AMENDMENT NO. 1

DATE: May 27, 2013

RE: VA Medical Center
5000 West National Avenue
Milwaukee, WI 53295

VA Project No. 695-324

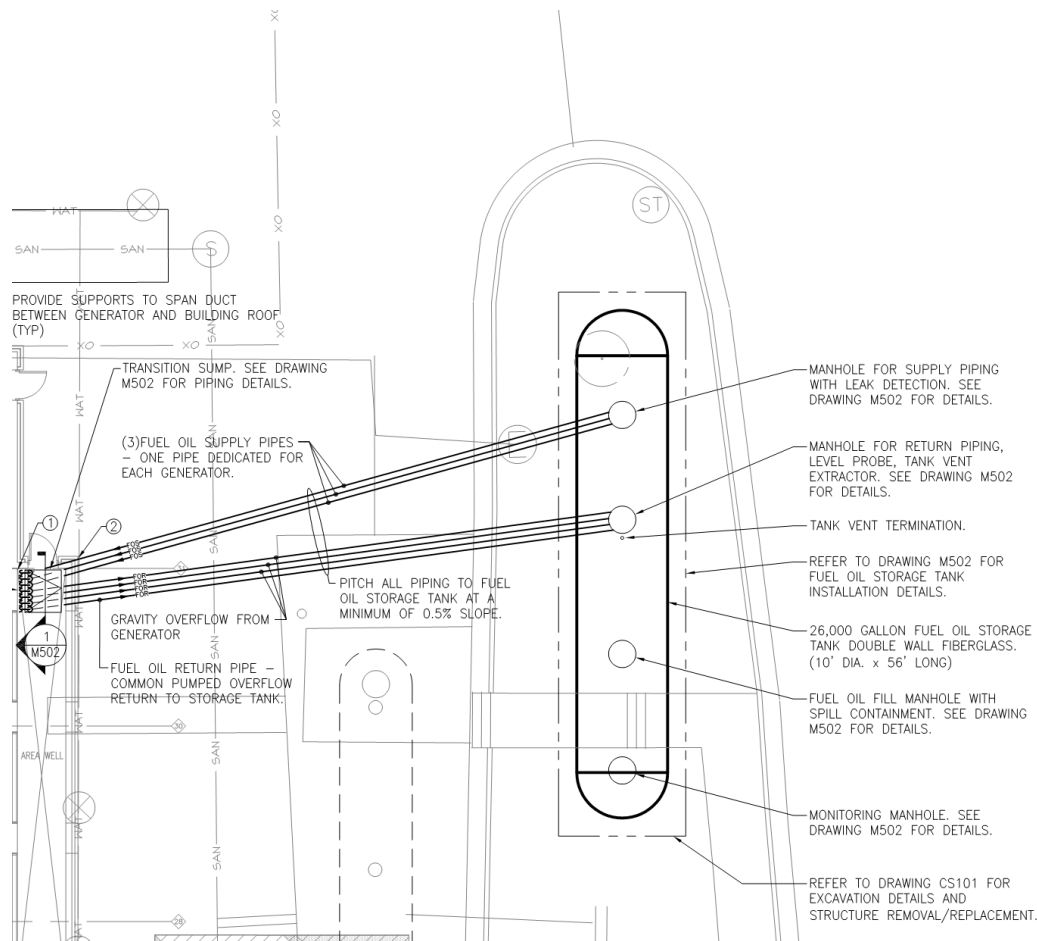
7. Sheet EE107:
 - a. **ADD:** two (2) exit signs to level 3
8. Sheet EE501:
 - a. **REVISE:** detail #8 text that reads “to audio broadcast system” to “to audio broadcast system in IT room LL08”.
